Subject: Submission of Information Requirements and Required Clarifications Associated with the BHP Canada Exploration Drilling Project

**BHP Canada Exploration Drilling
Project EL 1157 and 1158
Information Requirement Responses**

File No: 121416241

Figure 1 Revised EIS Figure 6-17: Spotted Wolffish Distribution and Abundance Compiled from Canadian RV Trawl Survey Data (2012-2017) with Designated Critical Habitat

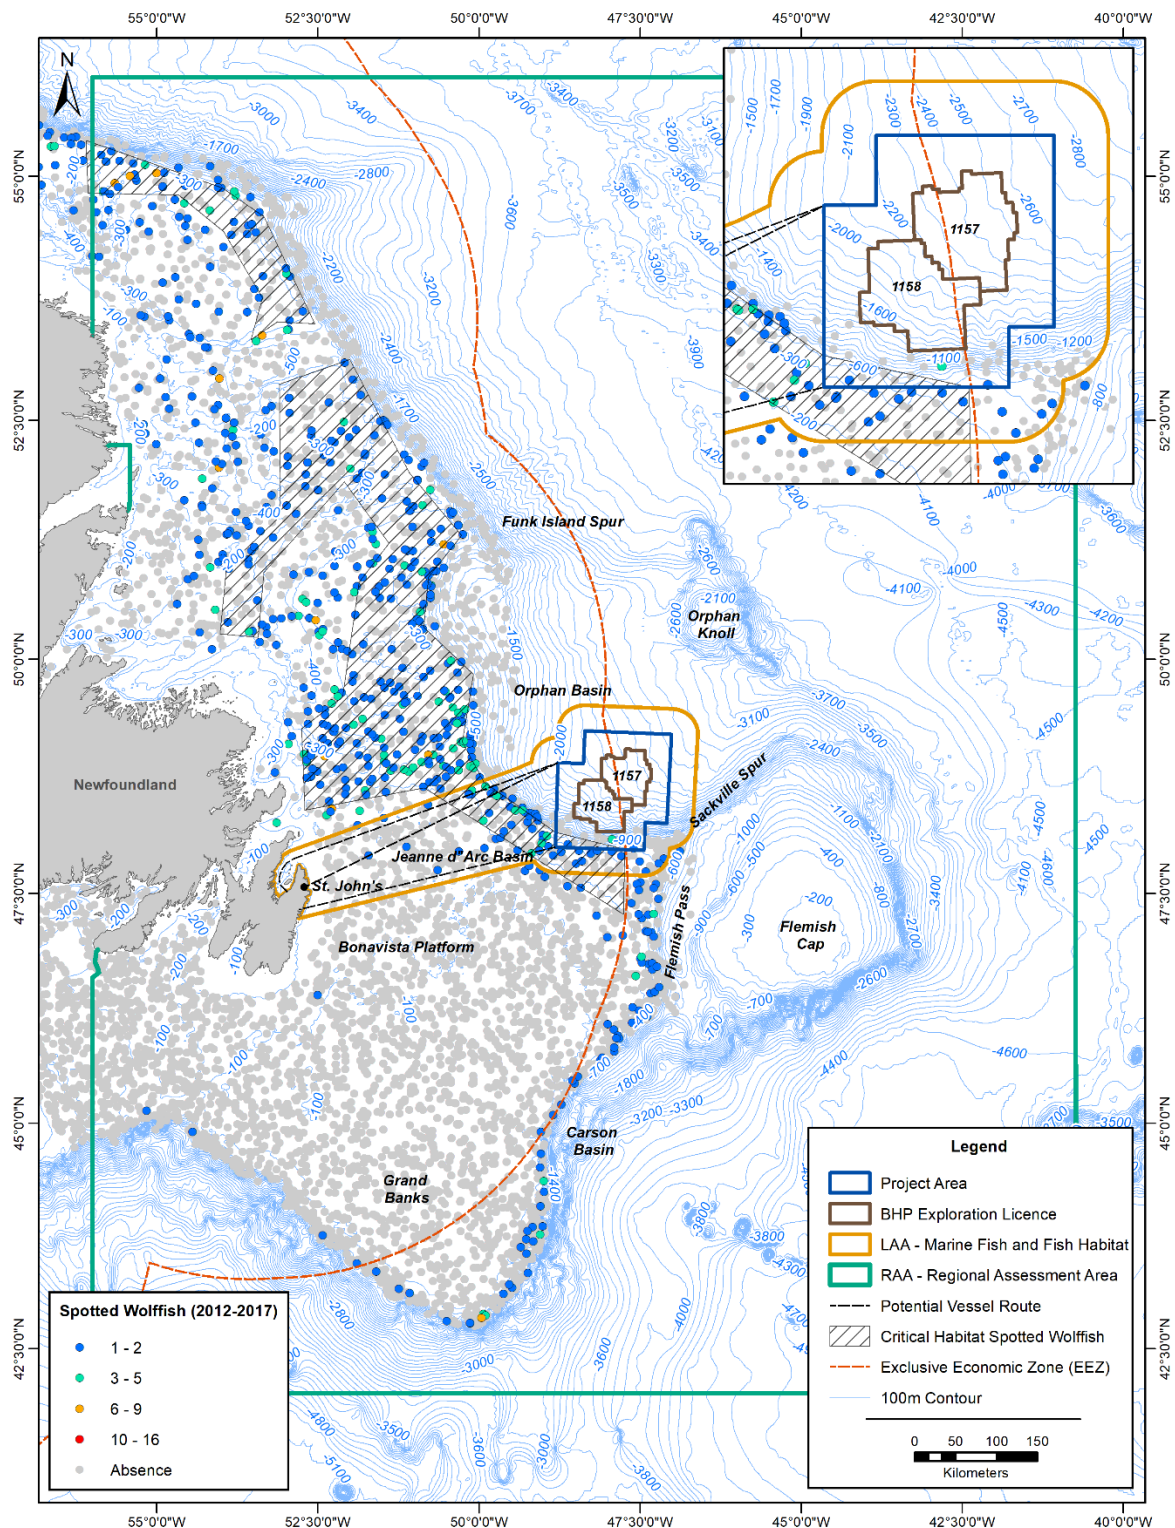
Confirm that figures in the EIS depicting wolffish critical habitat (e.g., Figures 6-17; 6-18; 11-1) remain accurate given the recently finalized boundaries. Similarly, confirm that the information on the overlap of wolffish critical habitat with the project area and LAA, as well as distances from spatial boundaries (e.g., ELs, project area, LAA, PSV routes) remain accurate. Update this information and these figures, as required.

There is no change to spotted wolffish critical habitat between the proposed and finalized boundaries as depicted on EIS Figures 6-17, 6-19, and 11-1. Finalized northern wolffish critical habitat (where it overlaps the spotted wolffish critical habitat) was extended to the Exclusive Economic Zone (EEZ). EIS Figures 6-17 and 6-18 depict the finalized Critical Habitat. Figure 11-1 depicts the finalized Critical Habitat, although it does indicate “proposed” Critical Habitat in the legend. Revised EIS Figures 6-17, 6-18, and 11-1 are provided as Figures 1 to 3, respectively.

Figure 3 Revised EIS Figure 11-1: Special Areas in the LAA

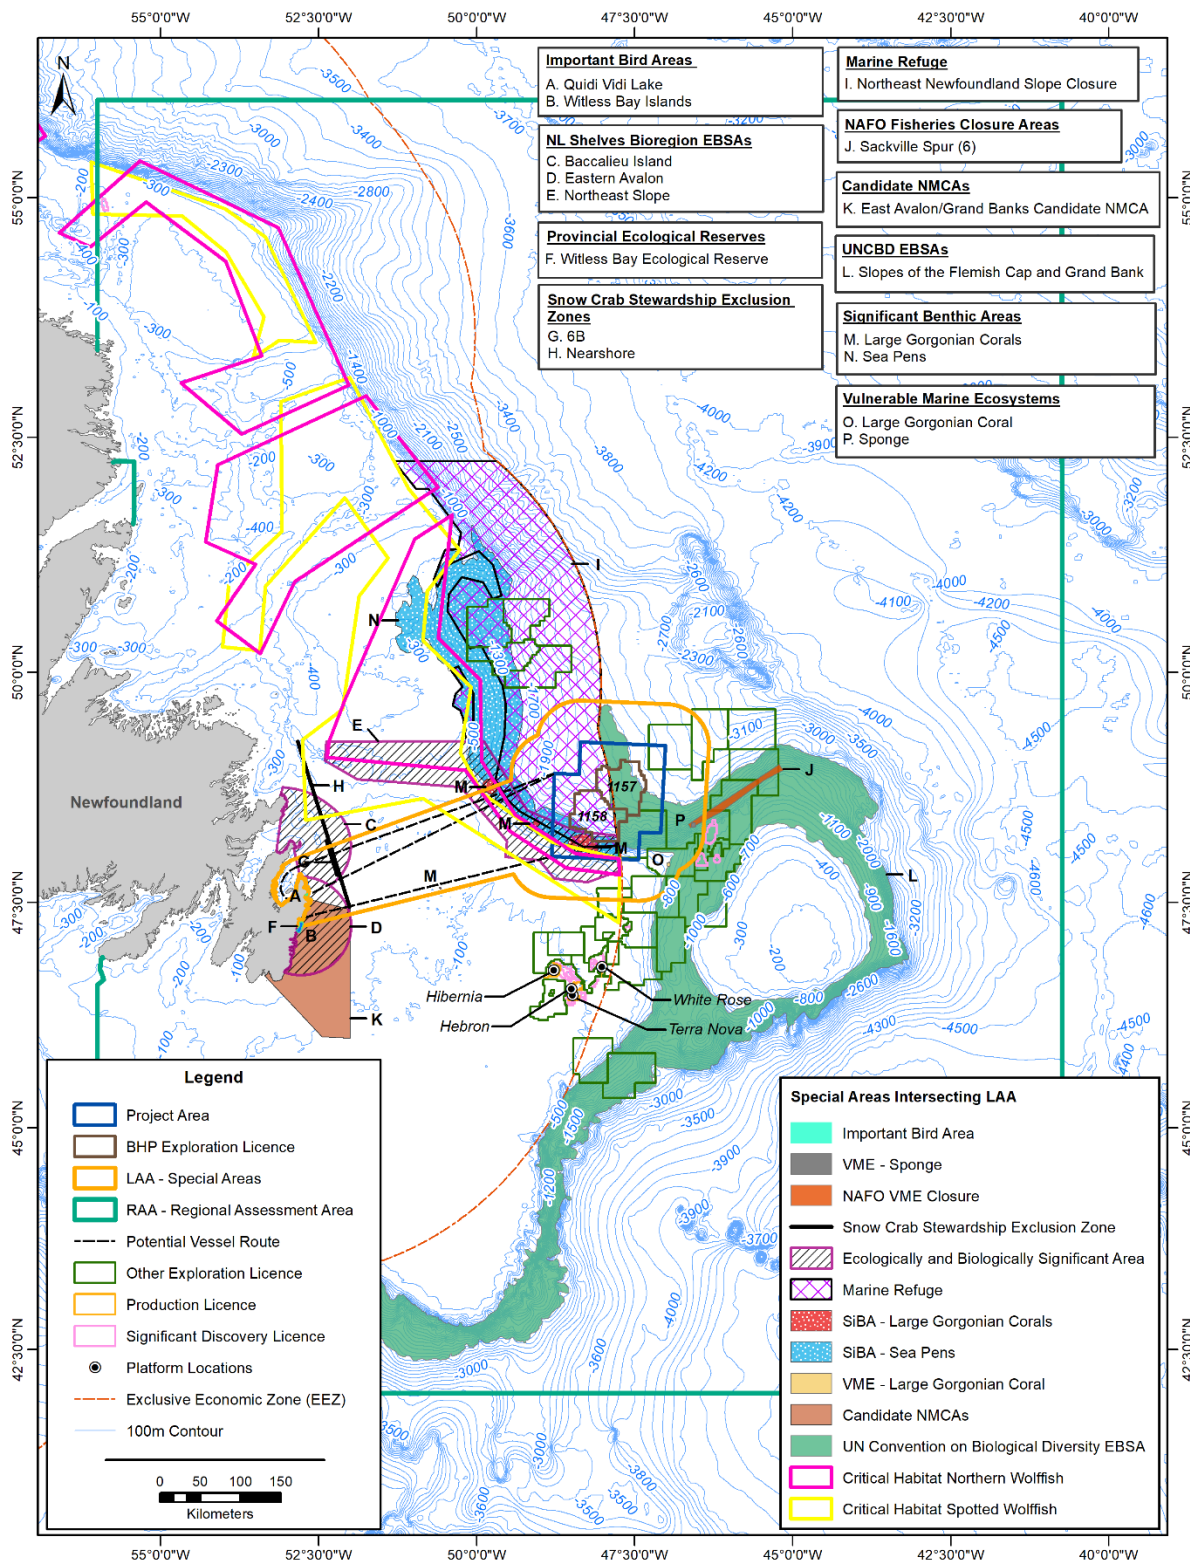
Figure 11-1 of the EIS identifies proposed critical habitat for Northern and Spotted Wolffish.
